**Committee of Experts on the Transport of Dangerous Goods
and on the Globally Harmonized System of Classification
and Labelling of Chemicals****Sub-Committee of Experts on the Transport of Dangerous Goods****Fifty-seventh session**

**Miscellaneous proposals for amendments to the
Model Regulations on the Transport of Dangerous Goods:
marking and labelling****Optical differentiation of placards for gases****Submitted by the experts from Spain and the International Association
of Fire and Rescue Services (CTIF)*****Revision****Background information**

Figure 5.3.1

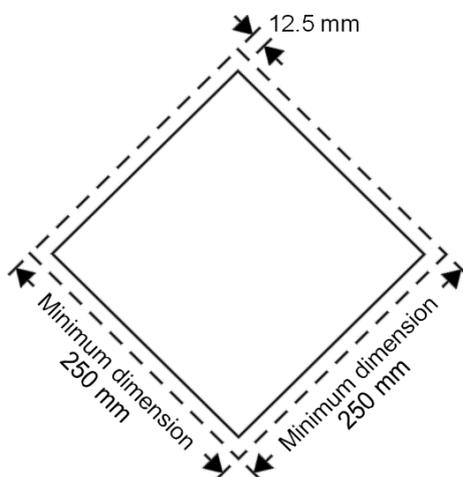
10. The expert from Spain and CTIF propose to modify the placards corresponding to Class 2, only for Division 2.1 and 2.3, to include the gas receptacle symbol into the lower part of the placard.

11. Therefore, the expert from Spain and CTIF propose to modify 5.3.1.2.1 including the following new sixth sentence (new text is underlined):

Figure 5.3.1

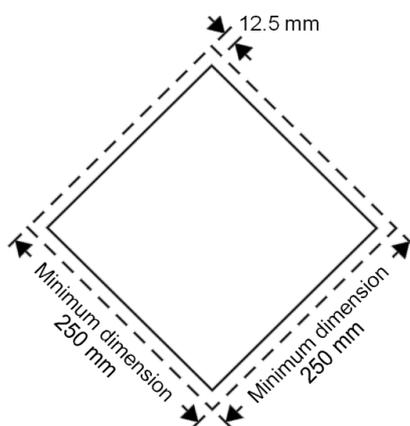
12. Alternatively it is proposed to modify the placards corresponding to Class 2, only for Division 2.1 and 2.3, to include the word « gas » into the lower part of the placard.

14. Therefore, the expert from Spain and CTIF propose to modify 5.3.1.2.1 including the following new sixth sentence (new text is underlined):
